THE RANCH SKETCH PLAN

LETTER OF INTENT

DECEMBER 2018

Figure 4: Extracts from the Falcon/Peyton Small Area Plan Recommendations Map

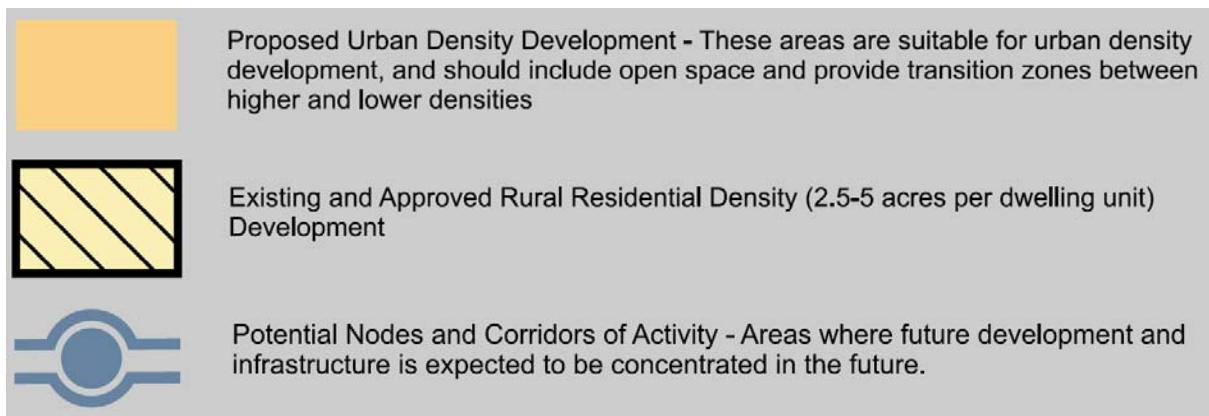
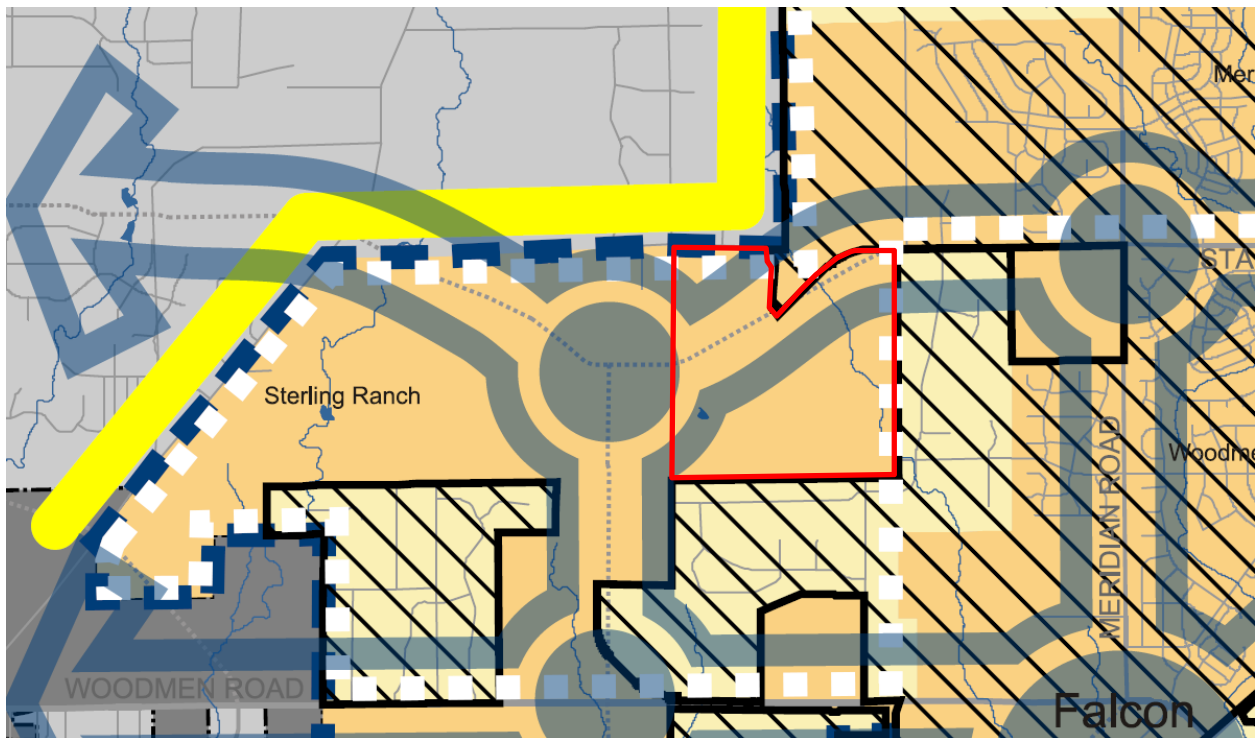
The whole Ranch is within Falcon Plan per graphic & Plan

The Stapleton Corridor needs to be mentioned as a subarea

That was there before the 2008 Plan was adopted... What about the NW portion where you have 1 acre next to RR5? Beef up transition argument and the Corridor discussion

Did the plan identify urban development to the north in paintbrush ?

Figure 5: Extracts from the Black Forest Preservation Plan

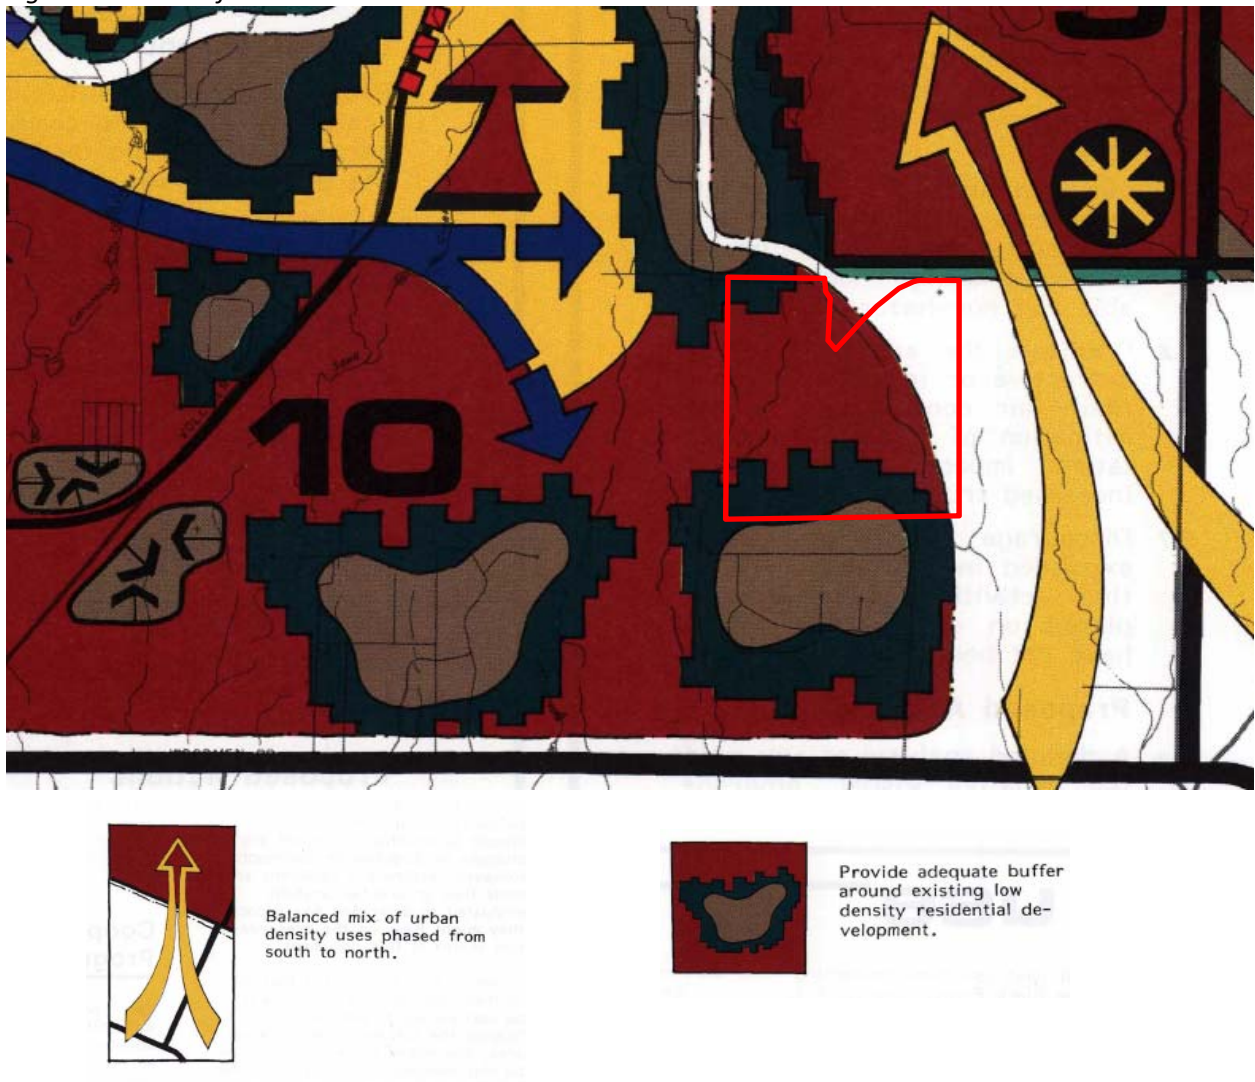
your analyzing this application in regards to Sterling and not the plan. Add more Plan discussion in relation to this SKP. Are you arguing that the Sterling SKP modified the Blackforest Plan in this area? If so state that first and say how above ..

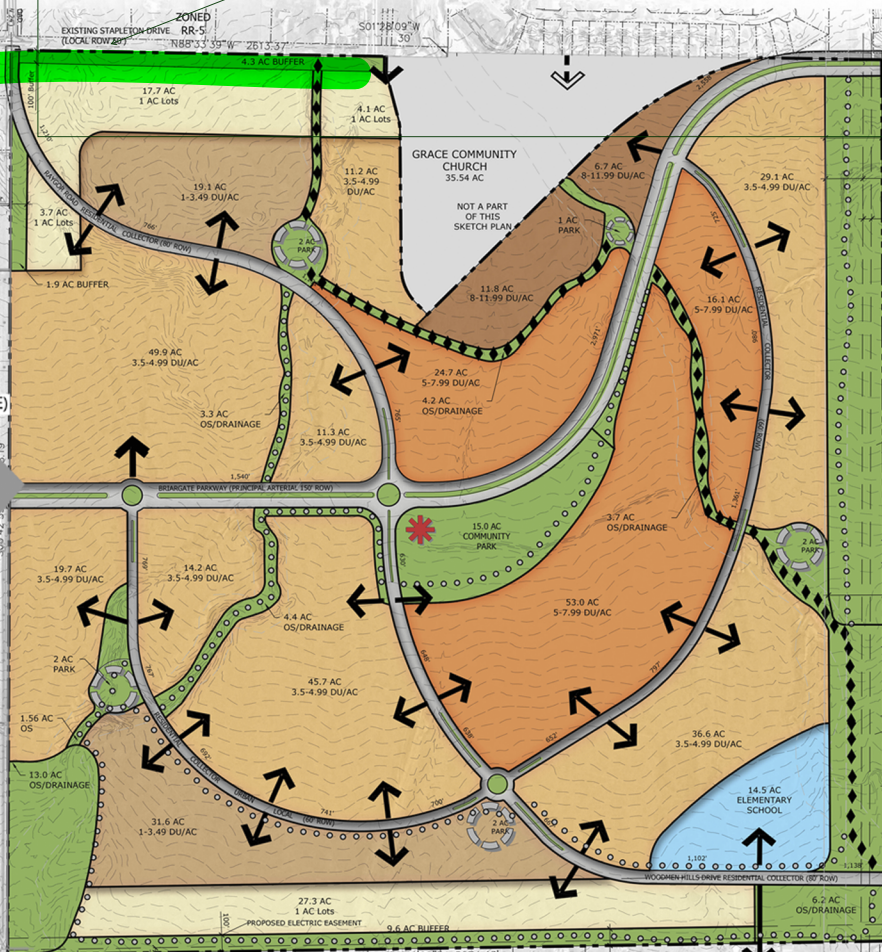
When the alignment changed the 1/4 mile transition from corridor would have dropped also or are you pointing out that the 1/4 mile remains where it was even though the road alignment changed for practical purposes?
